# UNITED STATES PATENT AND TRADEMARK OFFICE

APPLICATION NO.	FILING DATE	FIRST NAMED INVENTOR	ATTORNEY DOCKET NO.	CONFIRMATION NO.
10/761,144	01/20/2004	Martin Czech	Micronas.7397	1555

# Office Action Summary

## **DETAILED ACTION**

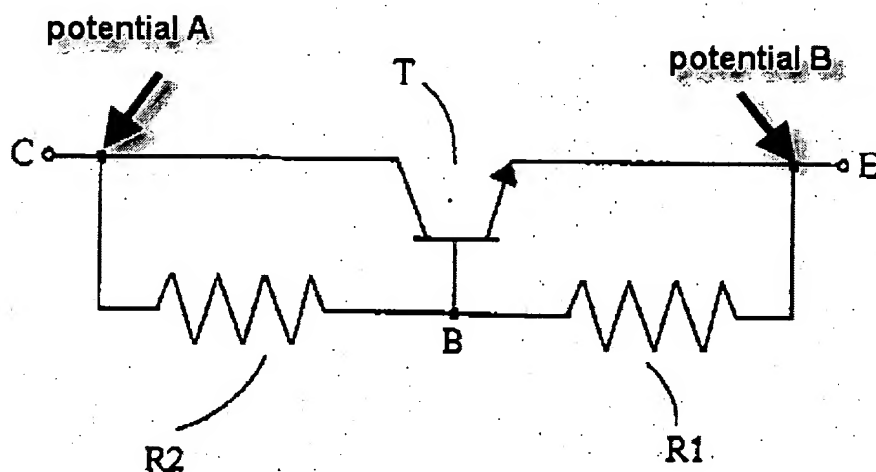
With regard to claim 1, APA discloses integrated circuit including at least two circuit components (1,2), which are formed on a semiconductor substrate of the first conductivity type and which each have a self-contained supply voltage system, and including at least one coupling circuit 4 which connects the same potentials (Vss1, Vss2; Vcc1, Vcc2) of the two supply voltage systems so as to intercept voltage spikes; the coupling circuit 4 includes at least one transistor 6

with a base of the first conductivity type, and a collector and emitter of a second conductivity type. (Note lines 16,17, page 3 of the Background of the invention, fig. 1 of APA).

APA does not disclose the base of transistor is connected through a resistance to the potentials, and the collector and emitter of transistor are connected directly to one of the potentials.

However, Scaccianoce discloses the base (B) of transistor (T) is connected through a resistance (R1,R2) to the potentials (A,B), and the collector and emitter of transistor are connected directly to one of the potentials (A,B). (Note see fig below, and fig. 1 of Scaccianoce).

Therefore, it would have been obvious to one of ordinary skill in the art to form the APA's device having the base of transistor is connected through a resistance to the potentials, and the collector and emitter of transistor are connected directly to one of the potentials such as taught by Scaccianoce in order to reduce voltage drop between the terminals.
